TRANSMITTAL OF RESPONSE TO COLORADO DEPARTMENT OF HEALTH AND ENVIRONMENT (CDPHE) COMMENTS OF DECOMMISSIONING CLOSEOUT REPORT FOR THE 883 CLOSURE PROJECT -- DWF-104-05

SUMMARY OF B883 CLOSEOUT REPORT RESPONSE TO COMMENTS TO CDPHE

Figure 7
IHSS 800-3
Structural Features Removed and Remaining

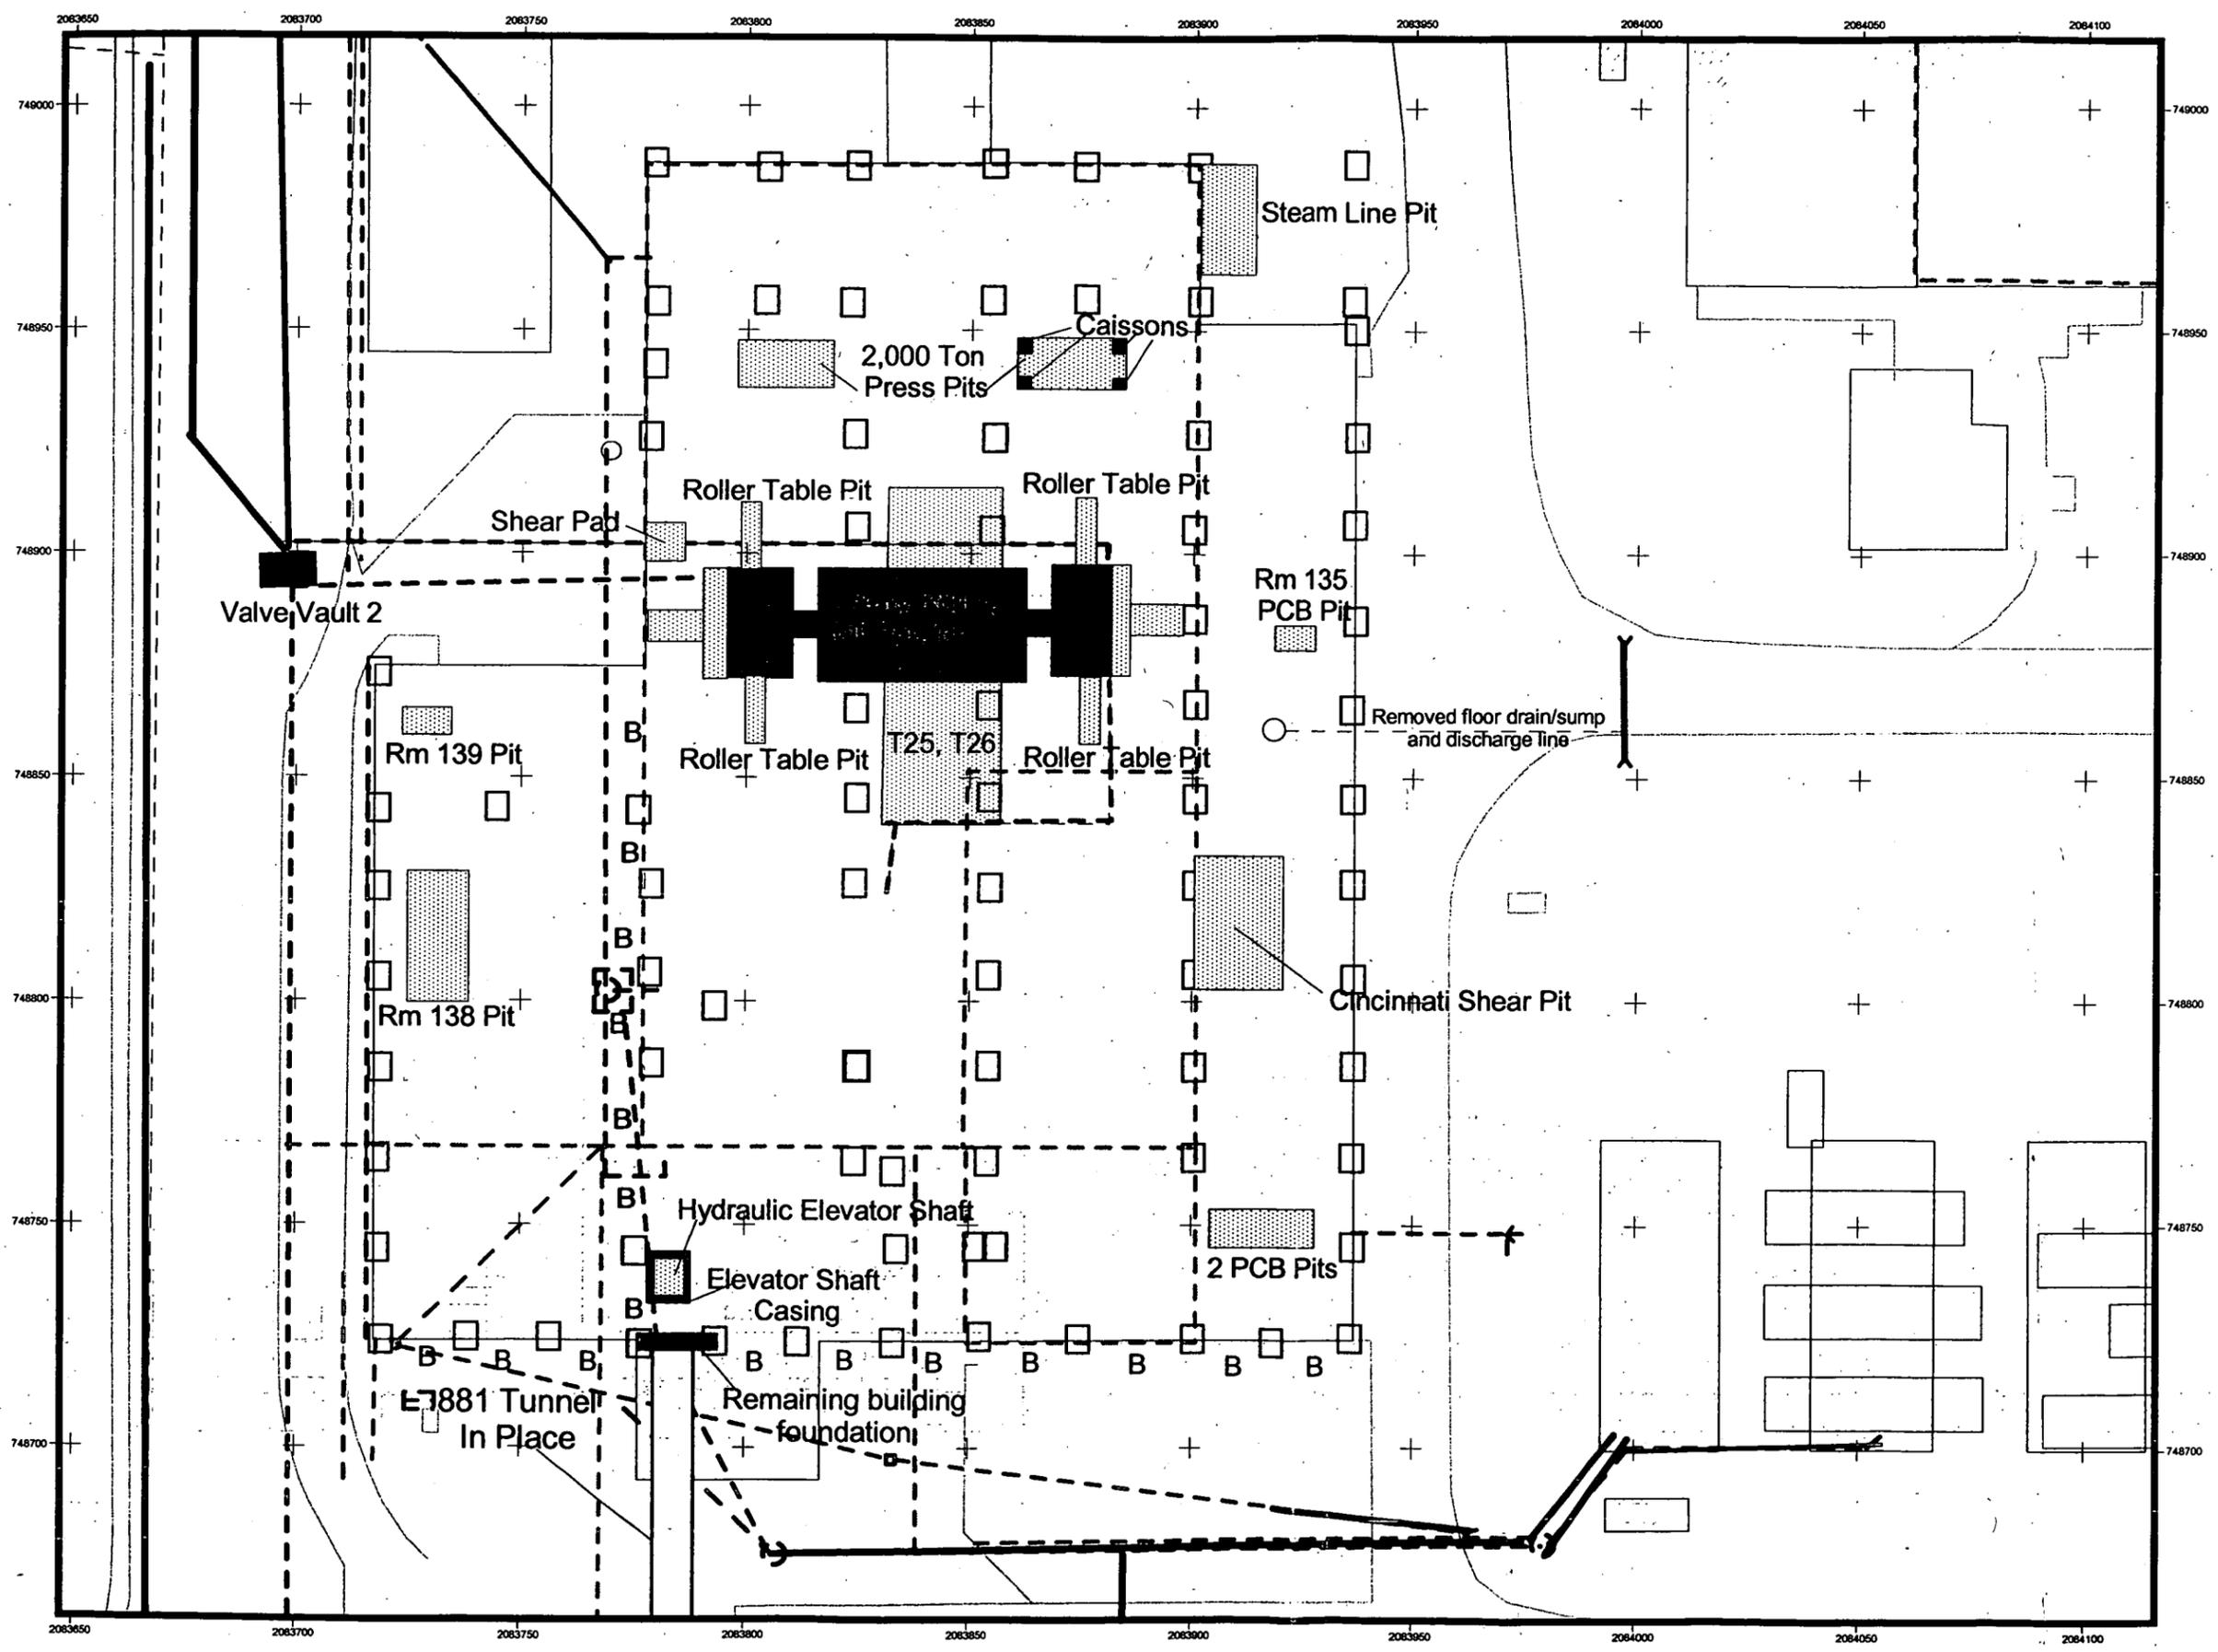
6. Section XI - Since at least some of the process waste line was not removed, this is remaining waste that needs to be discussed. Also please include a statement as to the condition of the remaining building structures, and sewer lines.

9. Figure 5 (or another figure to be provided) needs to show the disposition of the foundation drains and associated sumps. Also, please provide a figure showing all remaining infrastructure (footers/pedestals, 881/883 tunnel and associates walls, etc.). In addition it is our understanding that not all of the process waste line was removed, and that a small segment remains next to VV2, which may be shown but it is not possible to tell the difference between the removed and remaining lines. Please modify this figure, specifically the legend, to properly identify the different lines and when they remain or are removed.

See responses to #1 and #4 above. The attached figure depicts the remaining infrastructure left within the footprint of the facility.

The process waste line from B883 to VV2 was removed and indicated by hatched line on Figure 5. An additional figure from the ER Closeout Report for IHSS Group 800-3, June 2005 (their Figure 7) is provided that identifies the infrastructure that remains.
